GA No. : GA-14-002

TITLE: To change the size of the TC 26mm ammo series packing box.

In order to improve the packing quality for TC 26mm ammo series products, change the size of the TC 26mm ammo series packing box.and change the most packing quantity.

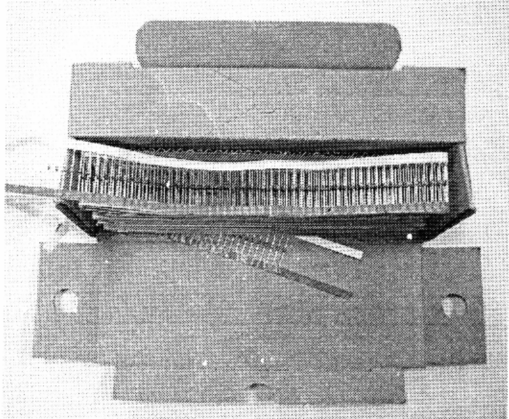
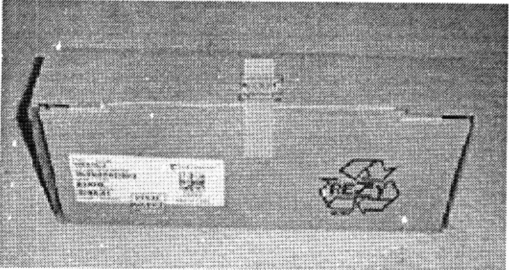
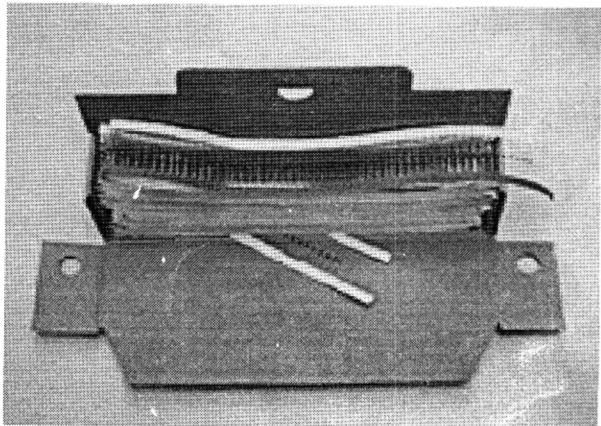
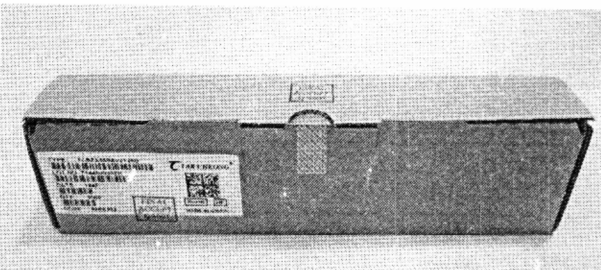
Item	From	To
<p>Inner box</p>	<div style="text-align: center;">  </div> <div style="text-align: center;">  </div> <p>Inner box size: 25.8*4.9*9.9 cm most packing quantity DO-35/DO-34: 5Kpcs DO-41: 3kpcs</p>	<div style="text-align: center;">  </div> <div style="text-align: center;">  </div> <p>Inner box size: 26.3*4.5*7.0 cm most packing quantity DO-35/DO-34: 5Kpcs DO-41: 2.5kpcs</p>

Out
box

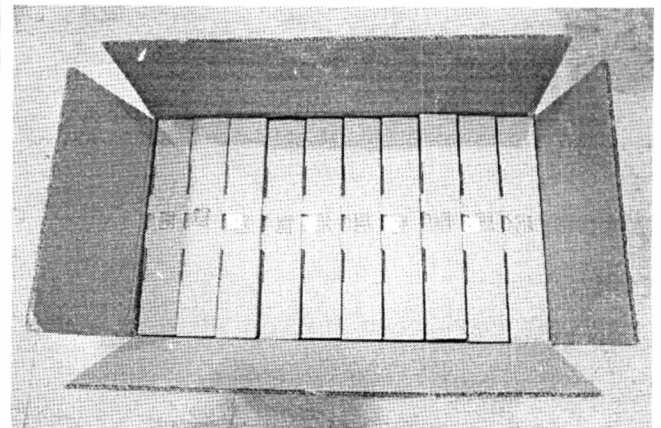
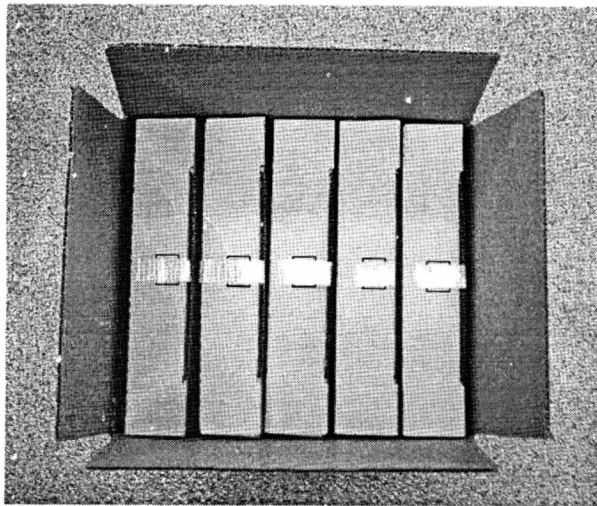
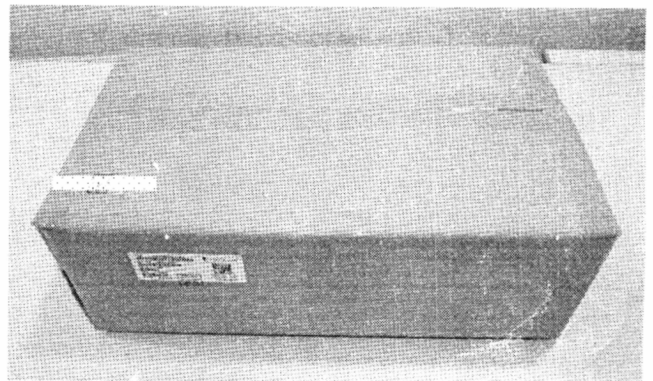
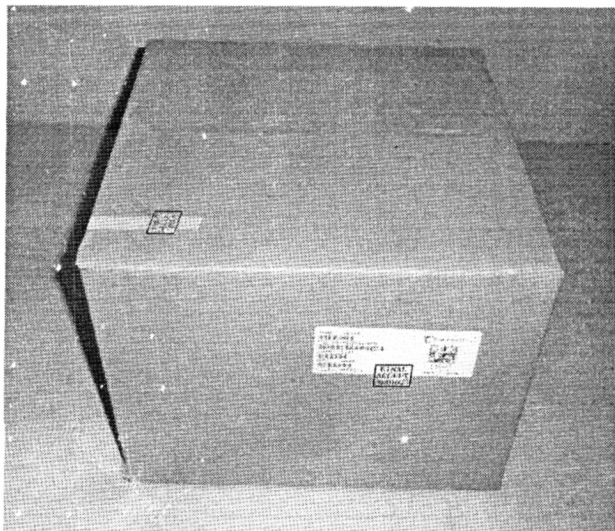
Out box size: 27*27*22.5cm

most packing quantity

DO-35/DO-34: 50Kpcs

DO-41: 30kpcs

Out box size: 47*27*16 cm

most packing quantity

DO-35/DO-34: 100Kpcs

DO-41: 50kpcs
